Theater Missile Defense Extended Test Range

Final
Environmental Impact Statement

November 1994

Volume I begins with the Executive Summary and Acronyms and Abbreviations. Section 1.0 of the Final EIS contains the introduction. Section 2.0 contains the additions and revisions to the Draft EIS and to the Supplement to the Draft EIS. Section 3.0 contains the responses to comments that were made on the two documents, and Section 4.0 includes an index to the commenters. Section 5.0 contains the agency comment letters and responses that pertain to the Draft EIS and the Supplement to the Draft EIS, while Section 6.0 lists the references used in the preparation of the Final EIS. Section 7.0 contains the list of preparers of the EIS, and Section 8.0 contains the distribution list for the document. Section 9.0 contains copies of the transcripts, exhibits, and written comments pertaining to the Draft EIS relevant to the Western Range Candidate Test Area. Section 10.0 contains copies of the transcripts, exhibits, and written comments pertaining to the Draft EIS relevant to the Eglin Air Force Base Candidate Test Area. Appendix A contains a discussion of cumulative impacts for the EIS, and Ap

Figure 3-11

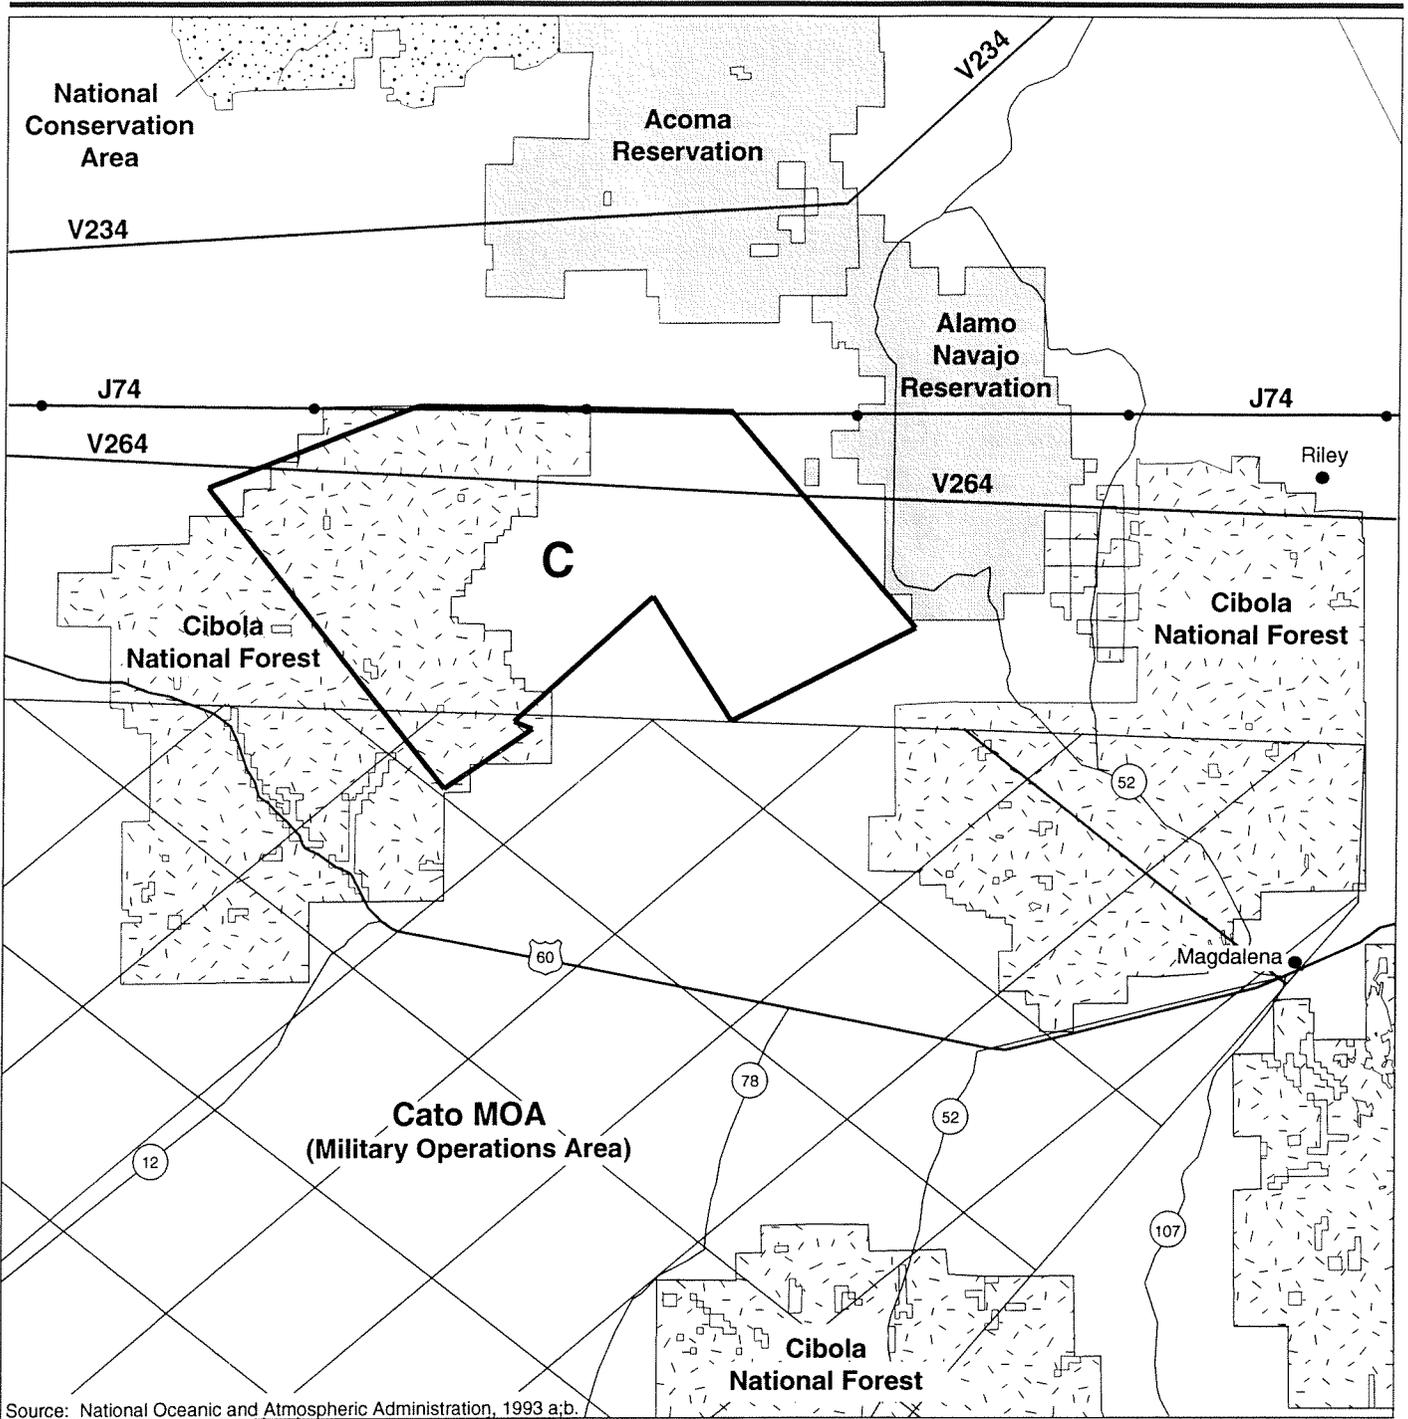
Page 3-29, figure 3-11 has been revised as shown.
